5.2 Advisory Agency Responses

NEW ACLAND COAL MINE STAGE 3 PROJECT

Figure 5.2-A - Clearance Map for Defence (June 2014)

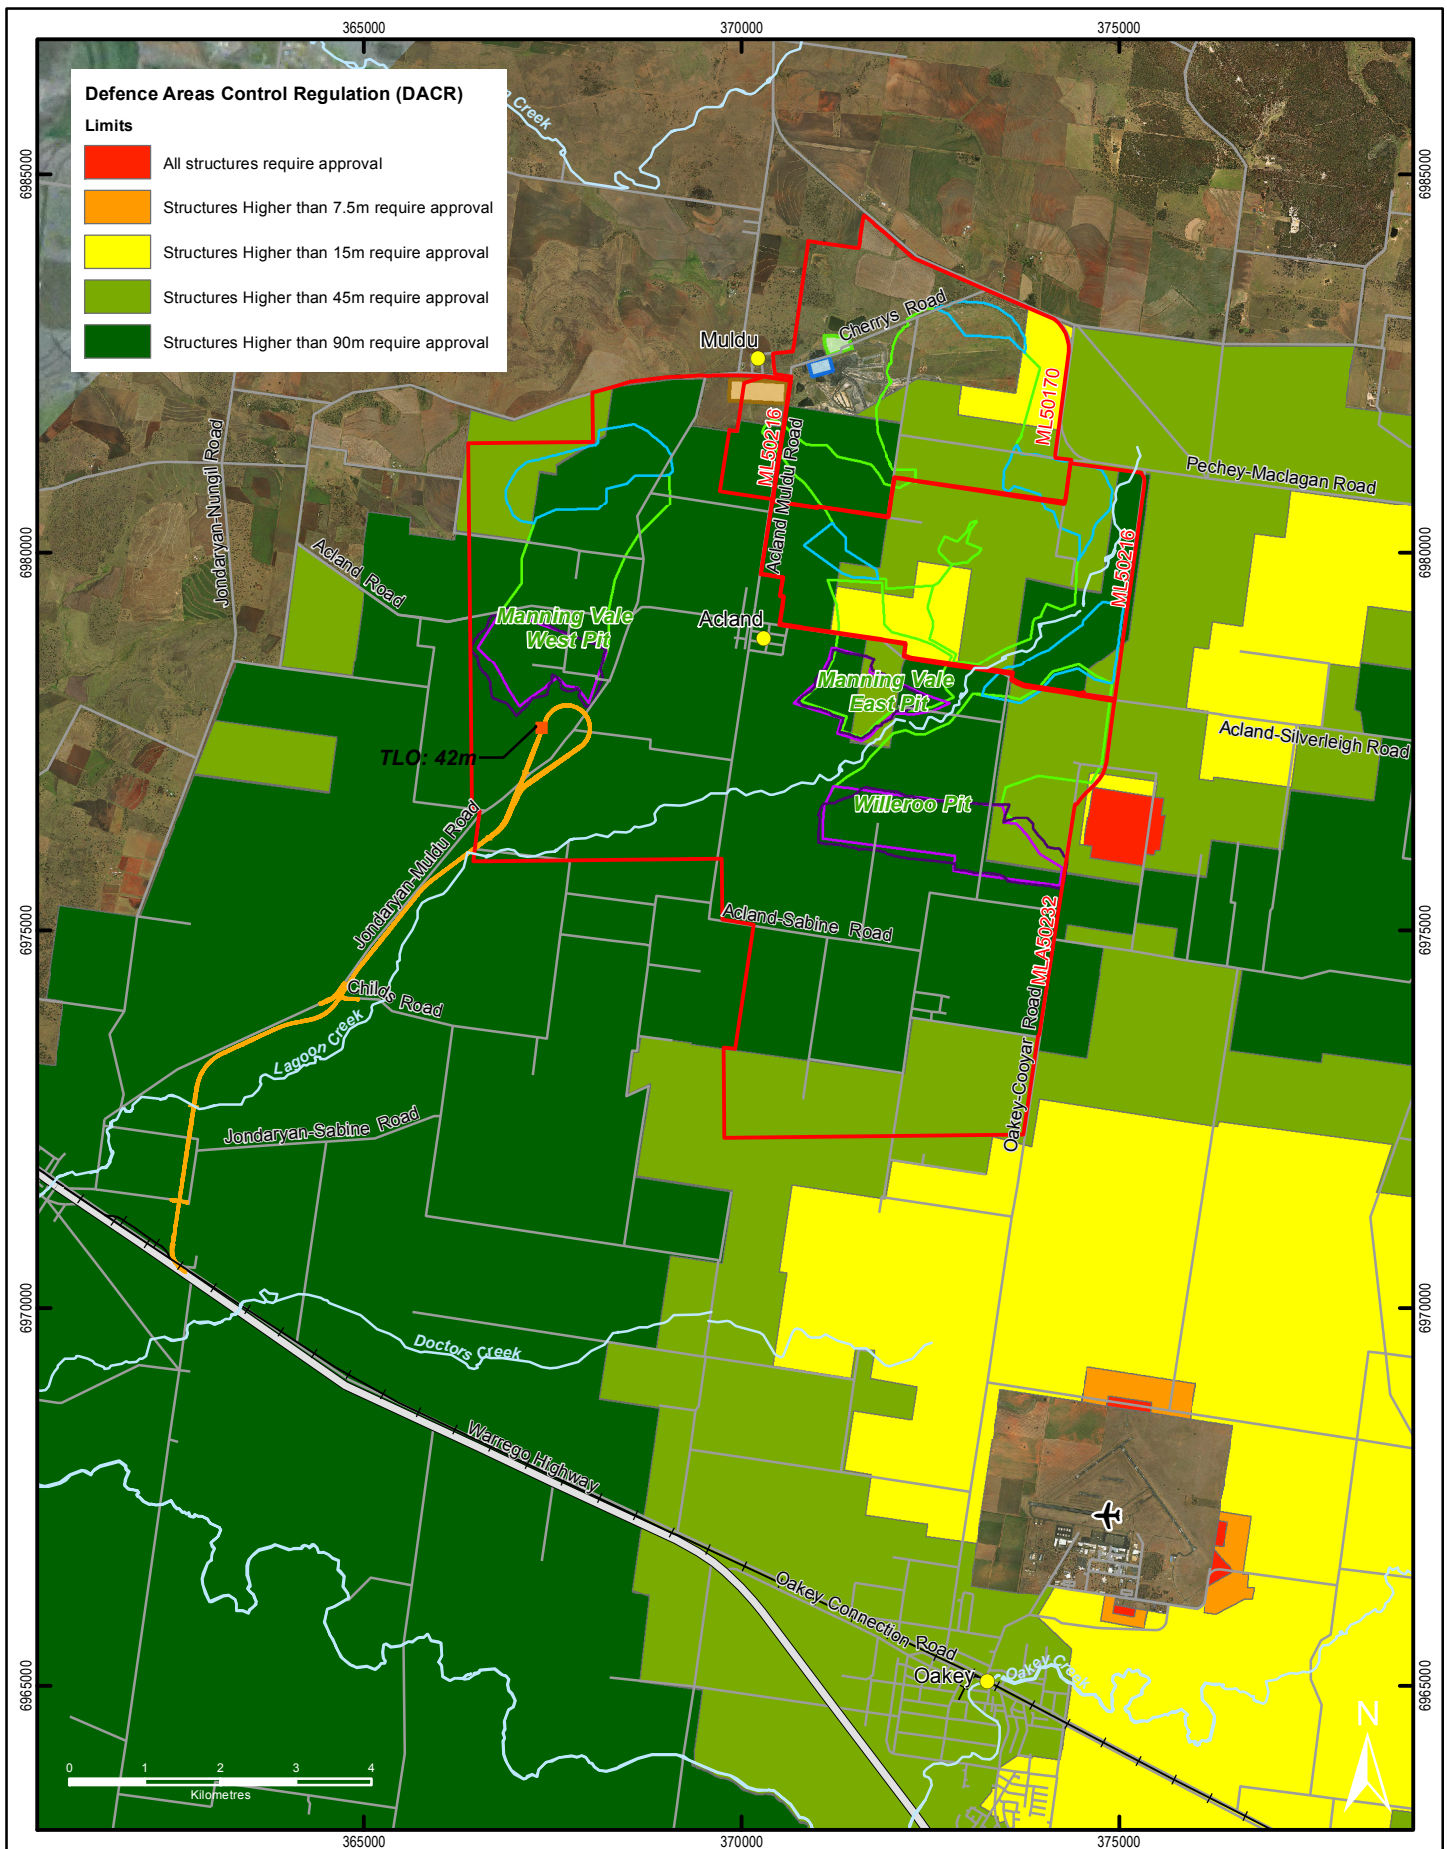
5.2.2.2 Issue 2

NAC takes note of the restrictions placed on the height of objects within a radius of approximately 15 km of Army Aviation Centre (AAC) Oakey as stipulated in the Defence (Area Control) Regulations. NAC will seek assessment and approval for any tall structures that is above 30 m above ground level within 30 km of the AAC Oakey, and any tall structures that is above 45 m above ground level elsewhere as depicted in **Figure 5.2-A** of the AEIS.

**Figure 5.2-N - Final Landform
Depth PMF**

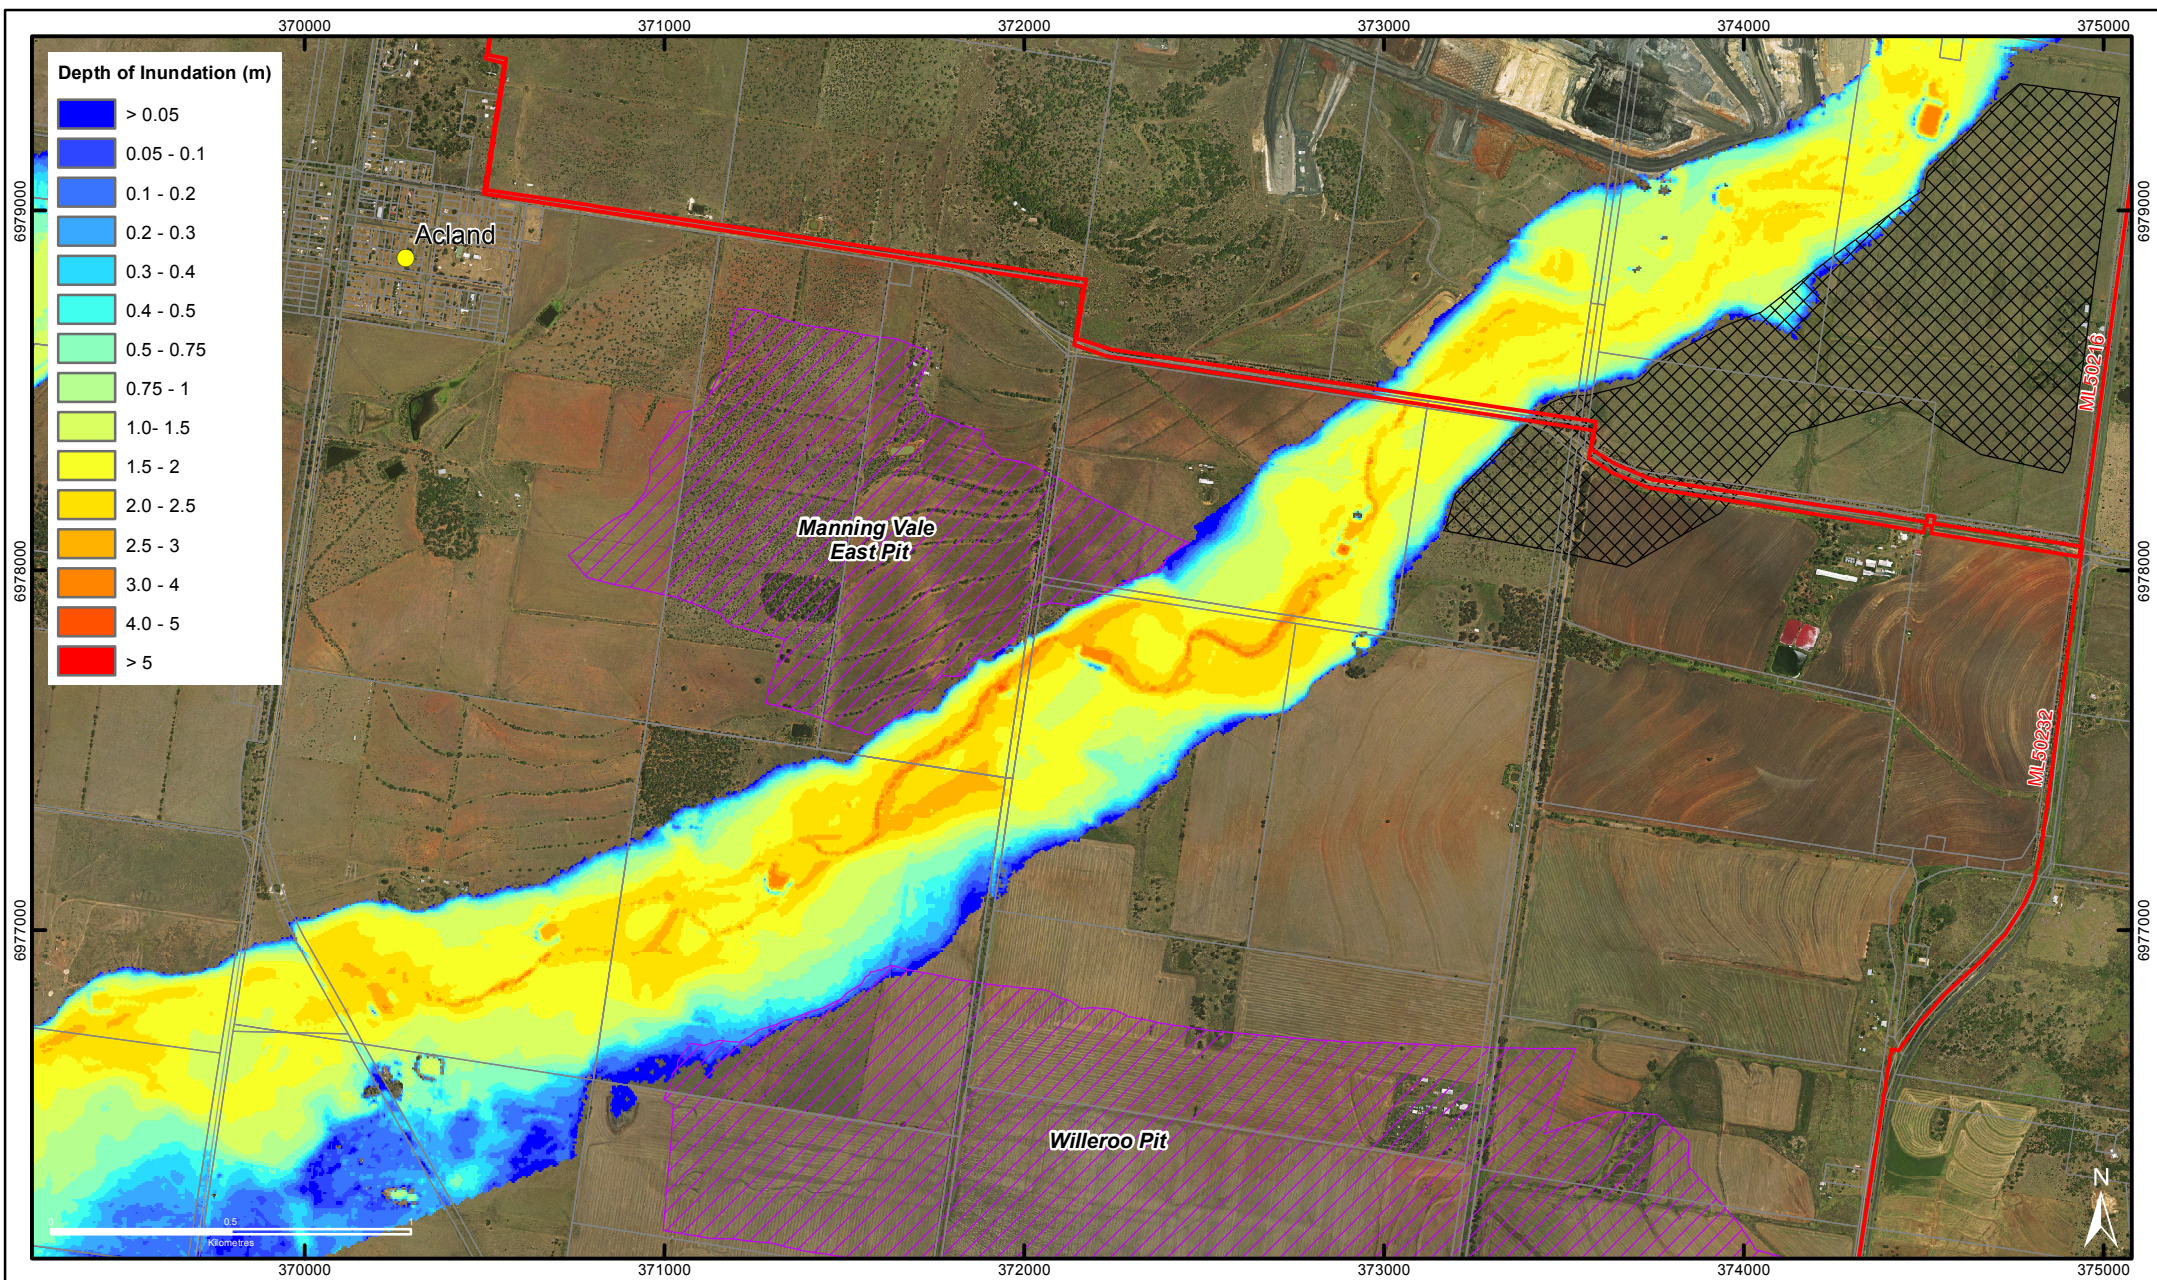
The following clarification is provided regarding DEHP's request for clarification as to the permanency of the Flood Levees. The Flood Levees will be removed at the end of operations as part of the revised Project's rehabilitation plans. The Flood Levee footprint will be as far as practical returned to natural surface as part of the revised Project's final landform.

Figure 5.2-N illustrates the approximate extent of the revised final landform presented relative to the existing PMF extent. It is noted that the PMF extent presented in Figure 5.2-N is the PMF based on terrain that does not include any flood levees. That is the flood extent is wider than that during mining operations and therefore the final landform is further away from Lagoon Creek than the mining activities during operations.

Figure 5.2-N illustrates that the final landform will be located marginally within the PMF extent with all levees removed. However it is noted that the extent as to which the depressed landforms encroach on the PMF is very minor and in areas where the predicted depth of flooding is less than 200 mm. Therefore it is not expected that depressed landform will impact on the PMF extent or behaviour. Any water that would flow into the depressed landform would be less than 1 ha of area over a depth of less than 200 mm. This volume is negligible relative to the volume of water in a PMF event. Given this and the extremely low probability of a PMF event occurring the impact is considered to be negligible.

Figure 5.2-N also illustrates that the toe of the rehabilitated out-of-pit dump to the north east of the Willeroo pit will also extend into the final landform. To examine the impact of this on the PMF the final landform was modelled and compared to that without the dump. The impact assessment found that any impacts from the final landform would be highly localised covering an area of less than 2 ha with a maximum increase in the flood level of 30 mm. Increase in peak velocities are also highly localised and expected to remain below 1 m/s and as such scour and erosion is not expected over areas of established vegetation. Importantly, no changes to the flood or flow regime were predicted downstream of this area and there are no changes predicted in the vicinity of Jondaryan. Given the extremely low probability of the occurrence of a PMF and that the impacts are very minor and localised the impact is not considered to impact on the environment, stability of the final land form or future land uses.

Figure 5.2-O Lagoon Creek Offset Cross Section

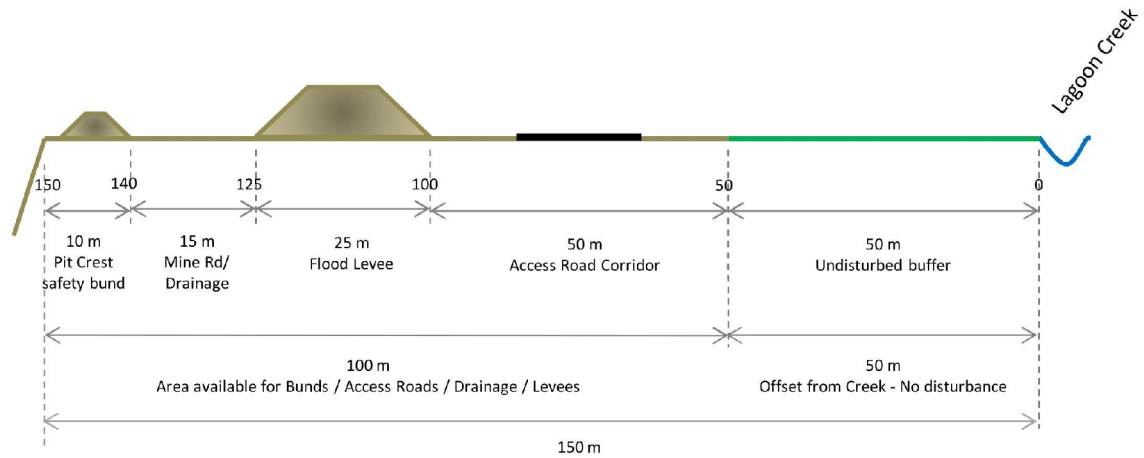
5.2.4.30 Issue 30

Where Lagoon Creek is clearly braided into multiple waterways, the operational offset zone will be determined from the edge or banks of the network of channels, to avoid the boundary of the 'no disturbance' buffer being located within the creek itself. Where the channel is indistinct, a line of best fit for the bank habitat will be determined by environmental staff, which defines the area of aquatic ecology habitat values. This approach of commencing the buffer zone at the creek bank will avoid the boundary of the buffer zone being located within the creek itself.

The cross section in **Figure 5.2-O** depicts a 50 m offset buffer that extends from the high bank of Lagoon Creek and will not be disturbed or utilised for any mining activity. This undisturbed buffer extending from 0 m to 50 m will extend along the length of Lagoon Creek within the mine lease. The area that extends from outside the 50 m buffer to the mine pit will be disturbed and utilised for various mine infrastructure and activities as follows (note that distances are metres from the high bank of Lagoon Creek):

Figure 5.2-S Annual Controlled Release Volume

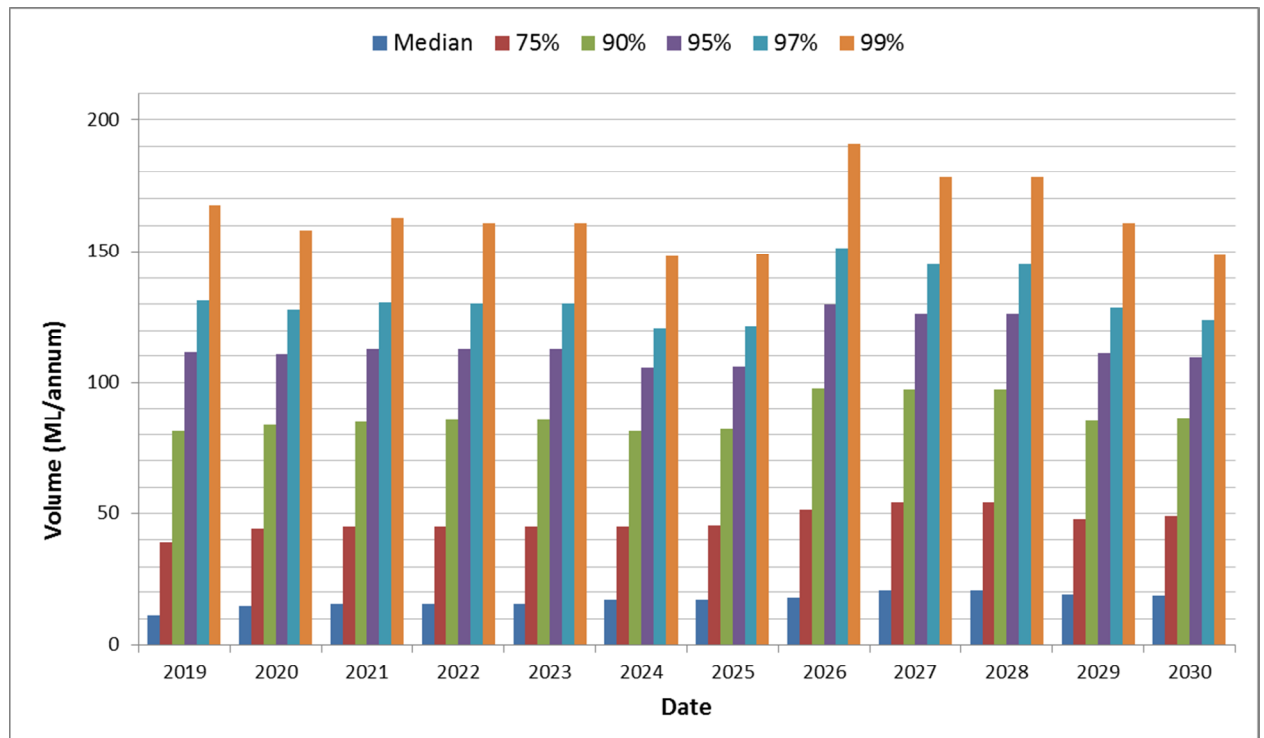
5.2.4.56 Issue 56

It is noted that the annual controlled release volume presented in **Figure 5-35** of the draft EIS and **Figure 5-3** of the Water Management Plan - **Appendix J.4** presents the total volume predicted to be released over a given year. That is at the 99th percentile of the probabilistic rainfall (very wet year) there is predicted to be 190 ML released in the year 2026. An updated chart is provided in **Figure 5.2-S** below.
